Westinghouse
Electric Corporation

SUBJECT: WESTINGHOUSE RESPONSES TO NRC REQUESTS FOR ADDITIONAL
INFORMATION ON THE AP600

NTD-NRC-96-4632

RAI's addressed in the January 29, 1996 submittal:

Figure 440.285-1 CMT Nodalization

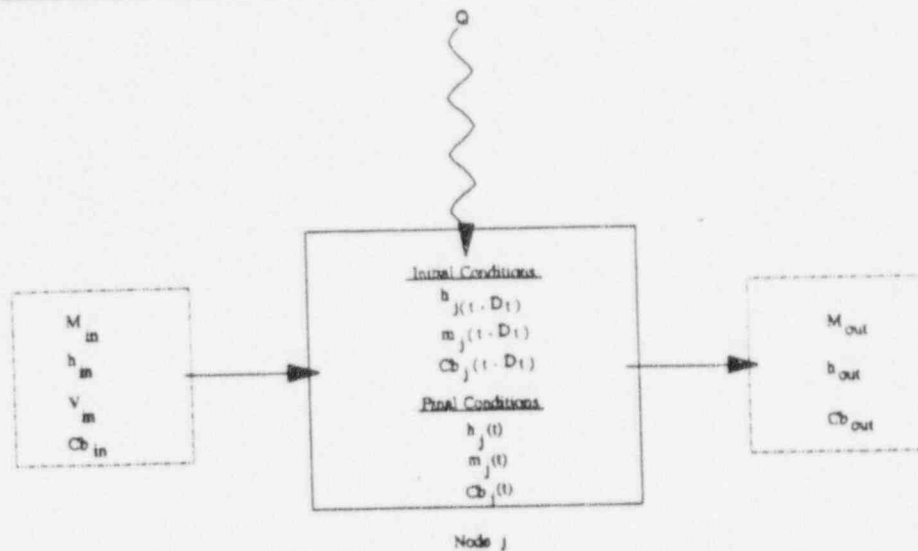
Section 3.1, page 3-1. Please provide a technical description of the equations, the nodalization, and numerical modelling of the CMT. Please explain whether local or global pressure is used in the CMT model and how donoring energy from the nodes to the links is performed. Also, please explain how thermal stratification (and its effect on condensation) is modelled in the CMT?

Figure 440.285-1 shows the noding used for the LOFTRAN CMT model in Chapter 15 SSAR analyses. Fluid noding in the CMT model is as follows:

- []^{abc} nodes in the CMT tank
- []^{abc} nodes in the injection line
- []^{abc} nodes in the balance line between the cold leg and the CMT
